*Approved Septic System Plan
Howard County Health Department
HOB + LOR BUR w/a
2000-gal Pump Tank
w/ Zoeller 0.4 hp Pump (BN152)
or equiv.
3/7/2019 Date
Signature
B19000230
13627 Curtis Vista Way*

PROJECT: BRIGHTON MILL II LOT 7	
LOCATION: TAX MAP: 34, GRID: 2, PARCEL: 16 ZONED: RR-DEO 13627 CURTIS VISTA WAY CLARKSVILLE, MD 21029 FIFTH ELECTION DISTRICT, HOWARD COUNTY, MD, TAX ID #600588	
TITLE: BAT SITE PLAN	
HOUSE TYPE: CLIFTON PARK - ELEVATION C	
DATE: FEBRUARY, 2019	PROJECT NO. 2627
SCALE: AS SHOWN	DRAWING 1 OF 6

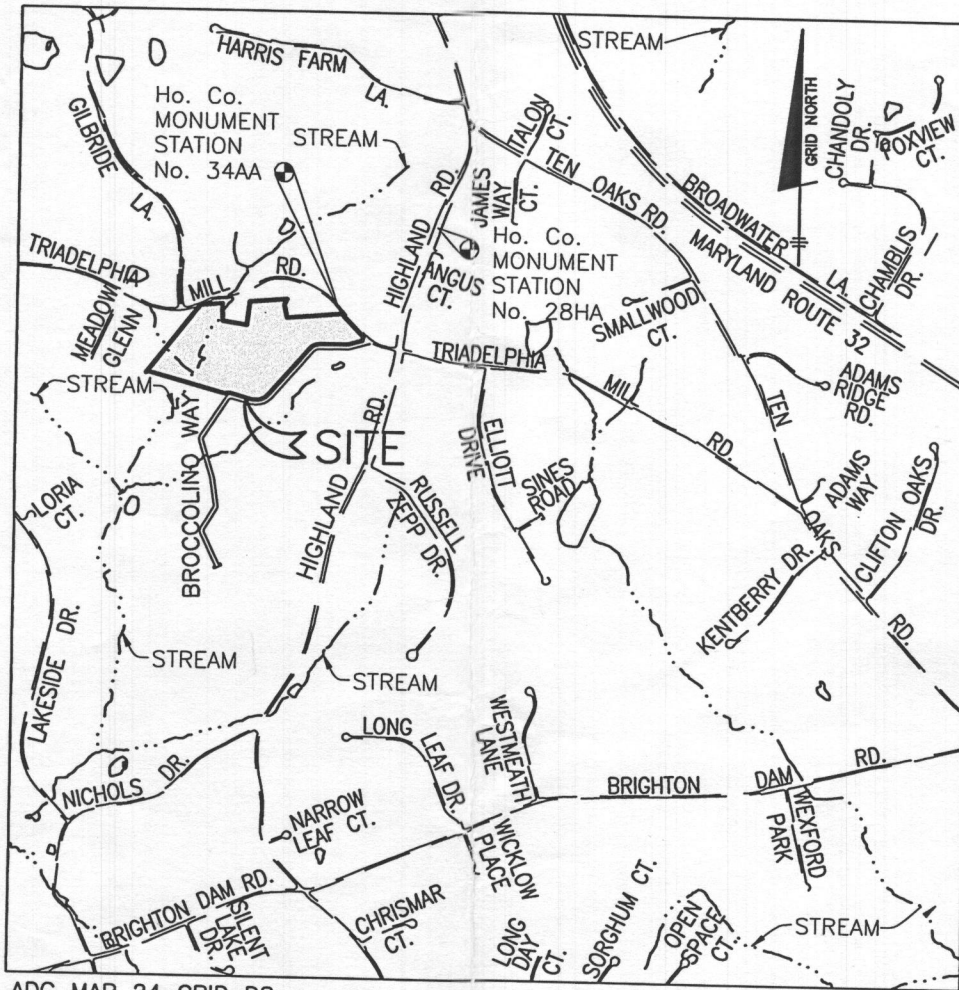
9. THE SEPTIC TANK WILL HAVE A 2000 GALLON 2 COMPARTMENT TANK. *see BAT unit RB*
10. ANY CHANGES TO THE LOCATIONS OR DEPTHS TO ANY COMPONENTS MUST BE APPROVED BY THE ENGINEER AND THE HOWARD COUNTY HEALTH DEPARTMENT PRIOR TO INSTALLATION. A REVISED SITE PLAN MAY BE REQUIRED.

PLAN VIEW
1" = 50'

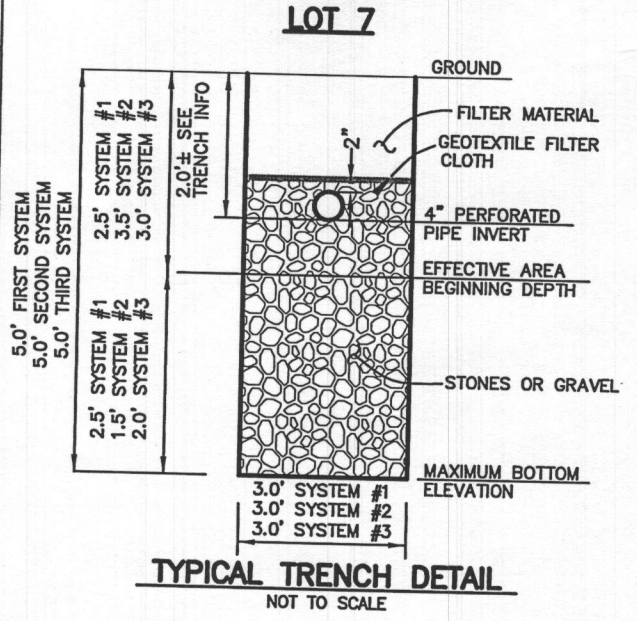
Not 600 BNR
2 2000-gal Pump Tank
w/ Zoeller 0.4 hp pump
R. Buick
Signature
3/7/2019
Date
B19000230
13627 Curtis Vista Way

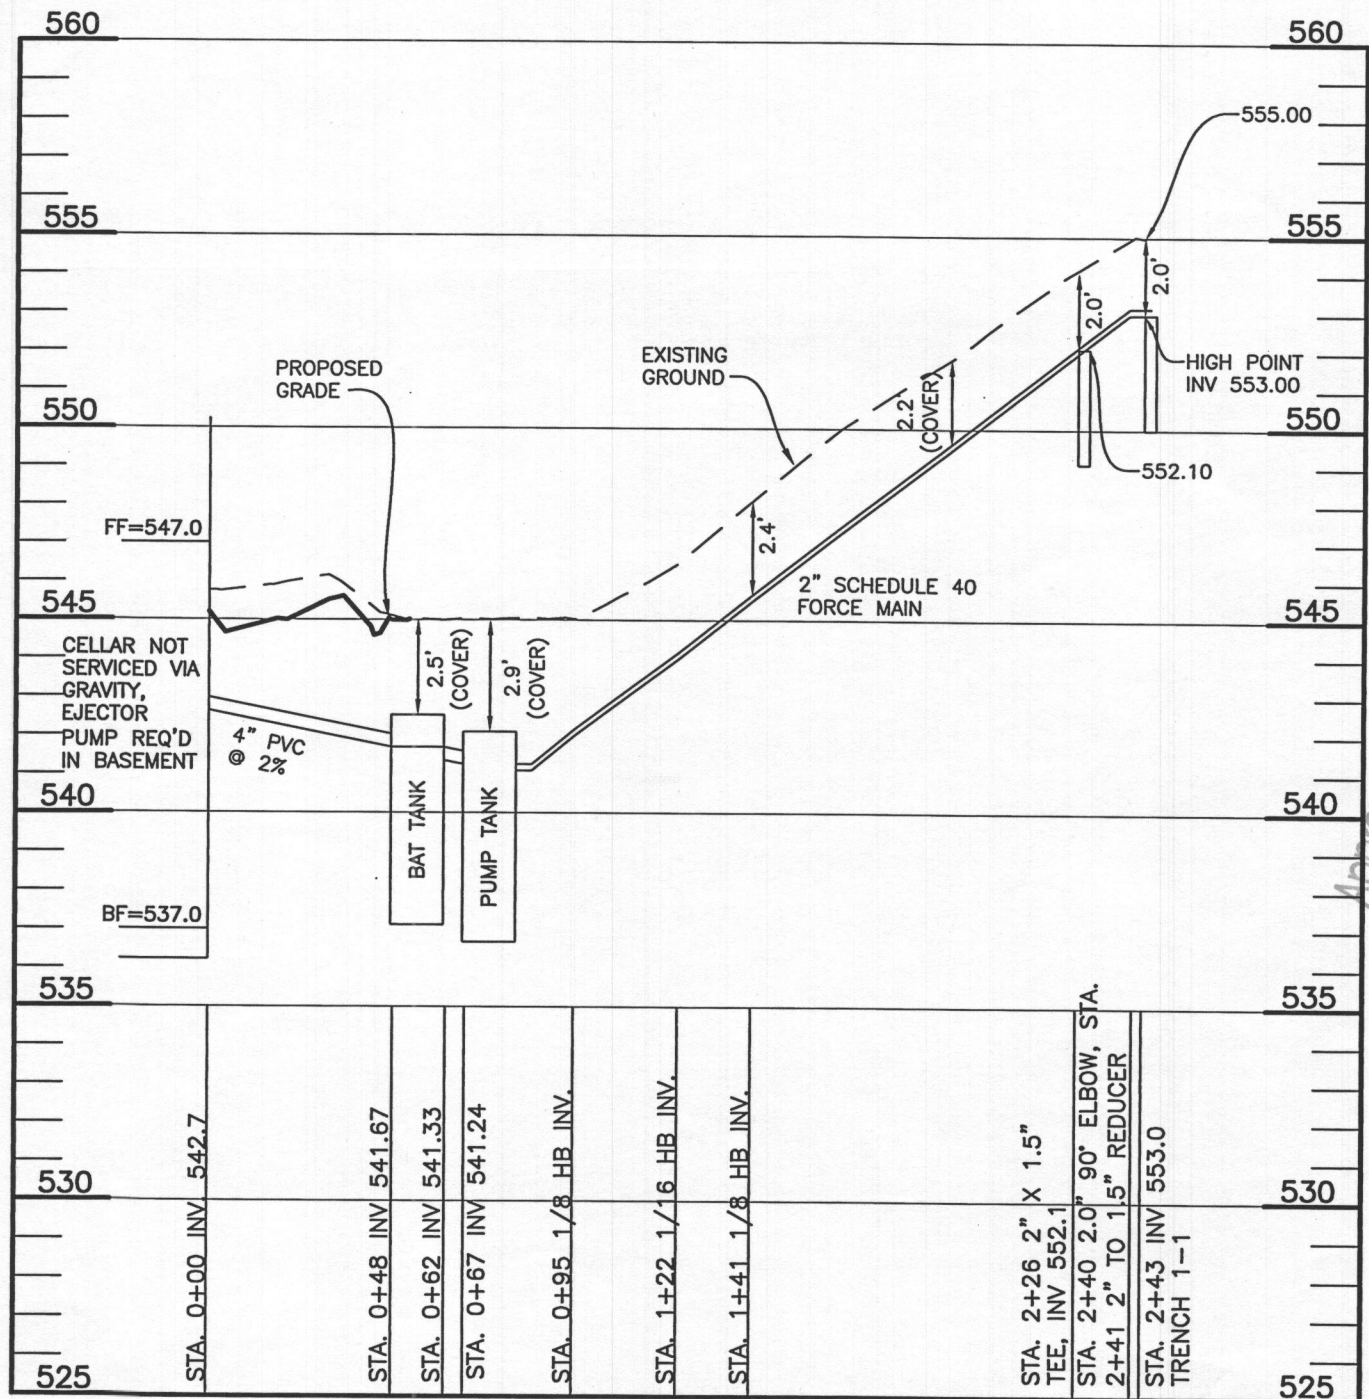
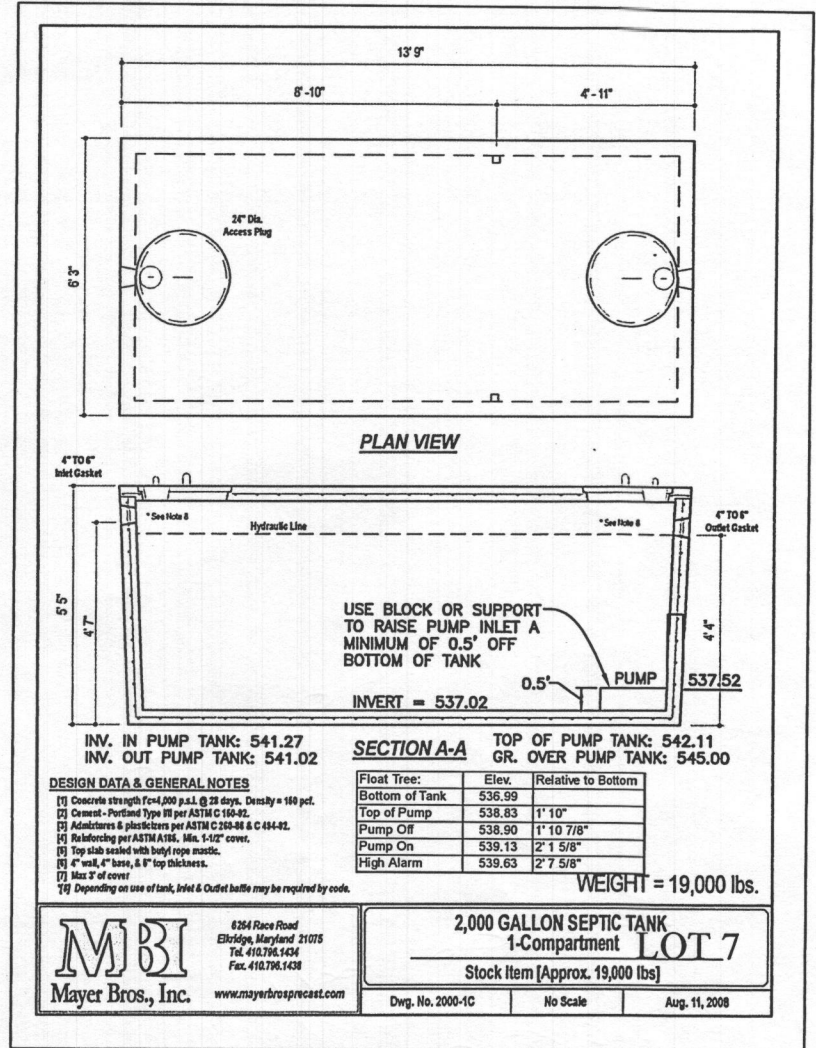
*Approved Septic System Plan
 BAT-LPD design approved for
 5-Bedroom floor plan
 B19000230
 Signature
 3/7/2019
 13627 Curtis Vista Way*

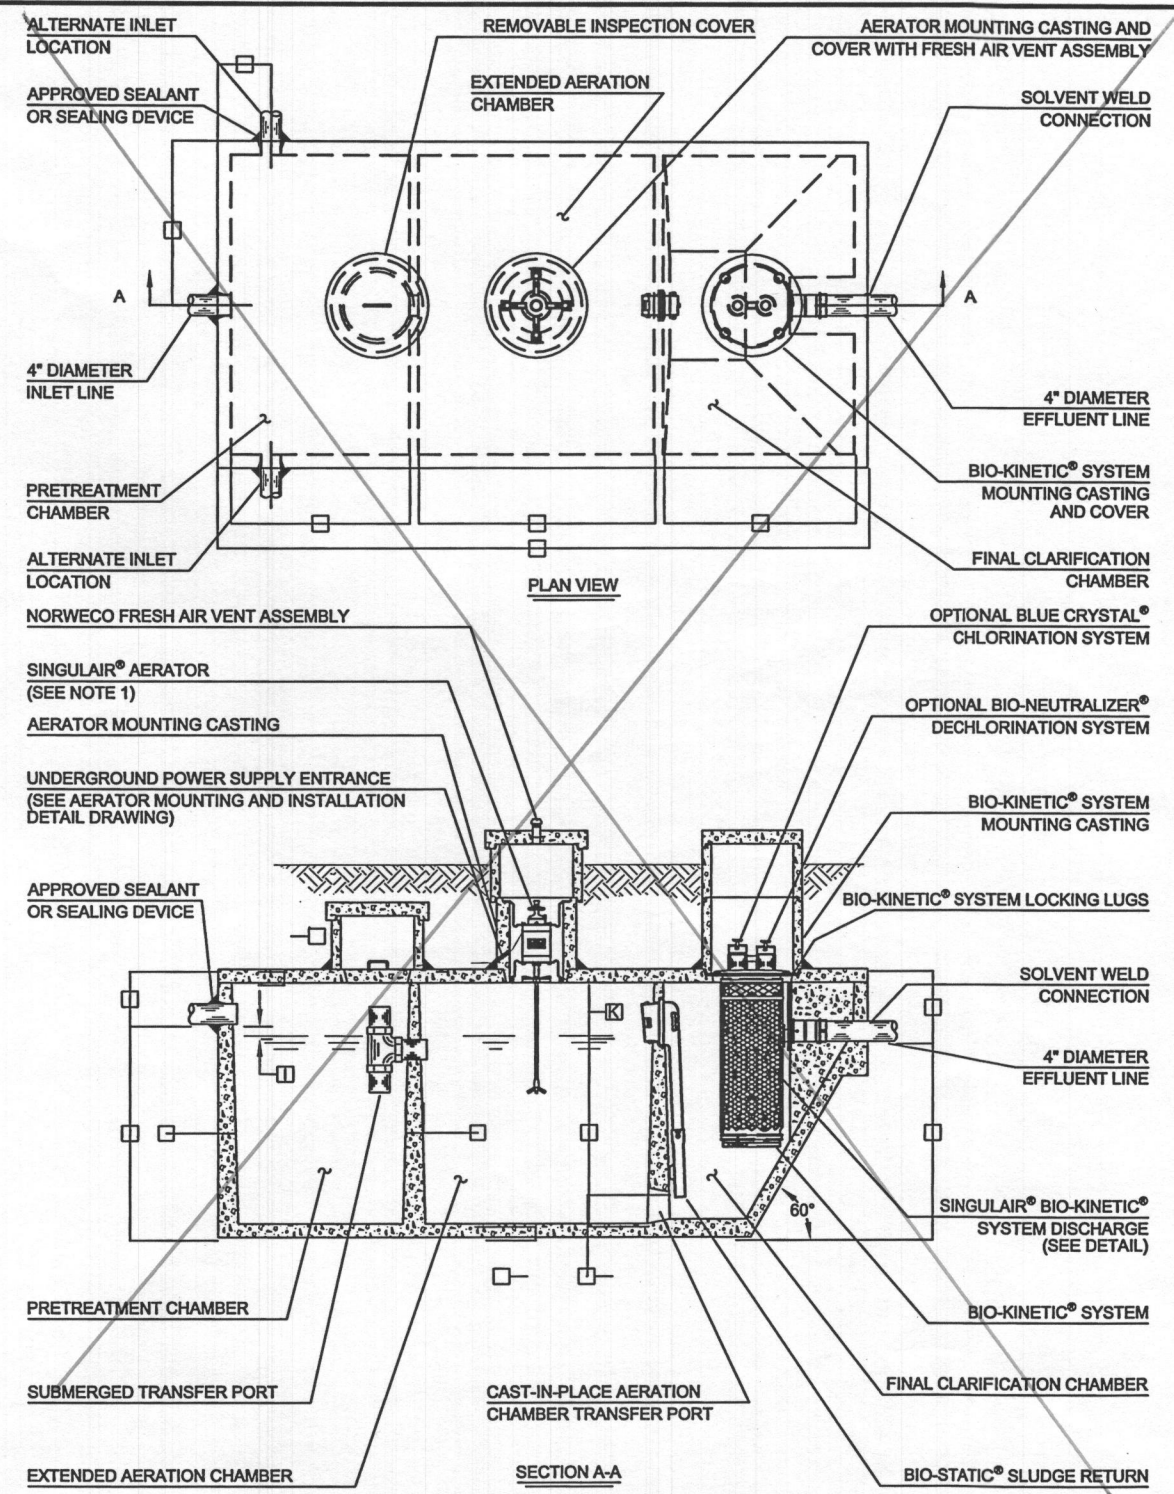
*OK! rd 3/7 2019
B19000230
B627 Curtis Vista Way*

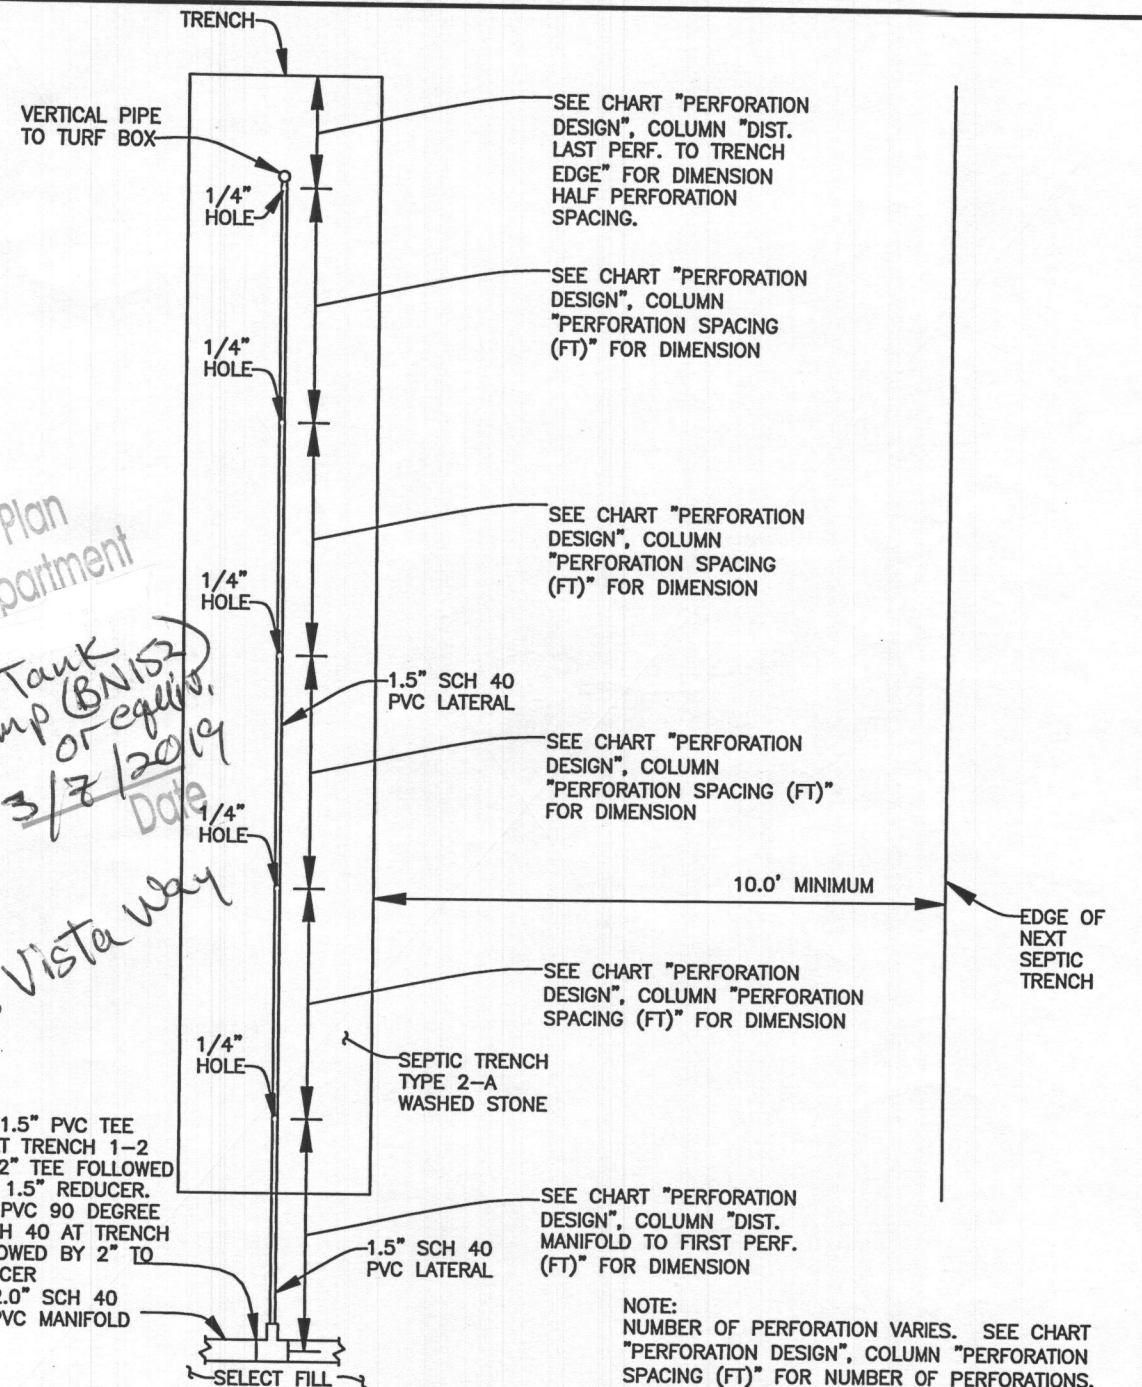
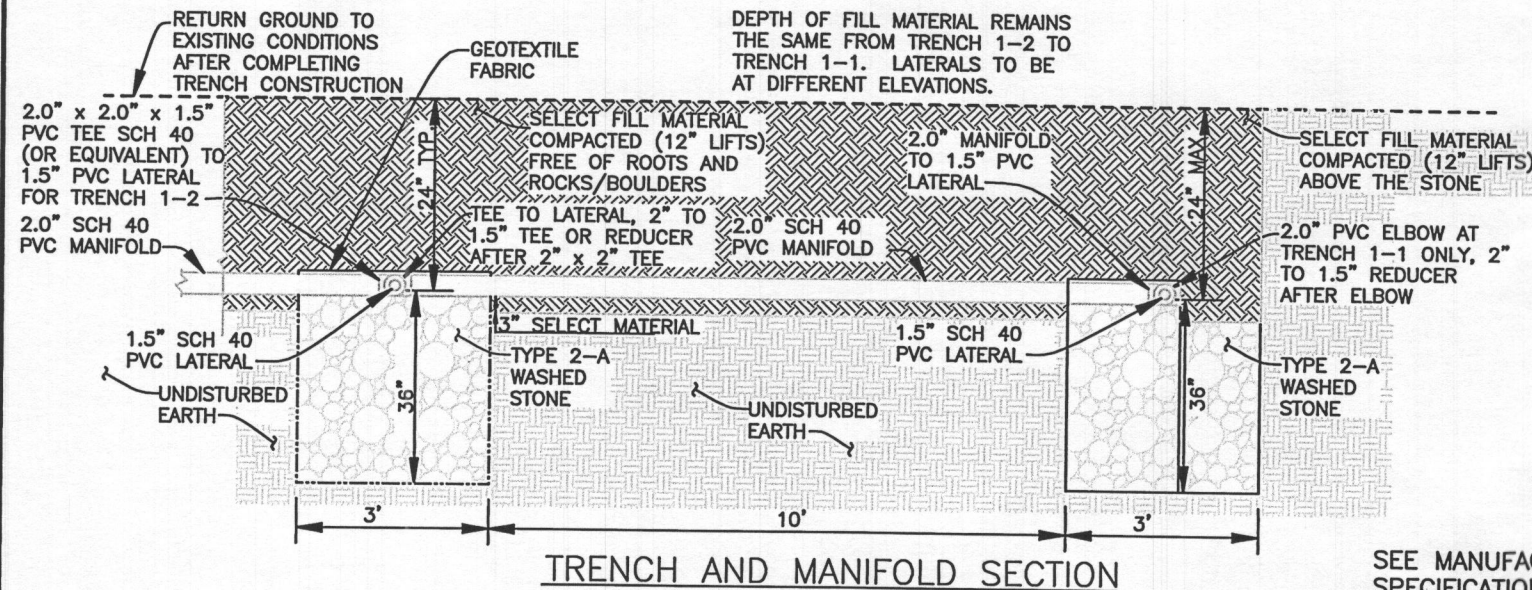
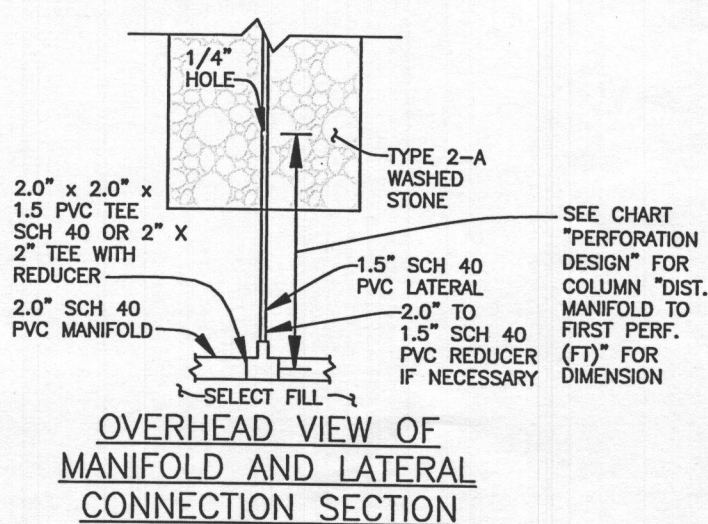
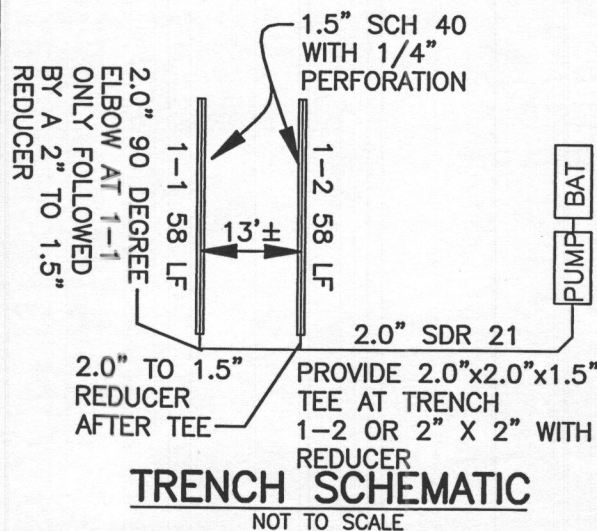
*Approved Septic System Plan
Howard County Health Department
14001 600 BNR
2000-gal Pump Tank
w/ Zoeller 0.4 hp pump (BN152) or equiv.
3/8/2019 Date
B. Busker Signature
B19000230
13627 Curtis Vista Way*
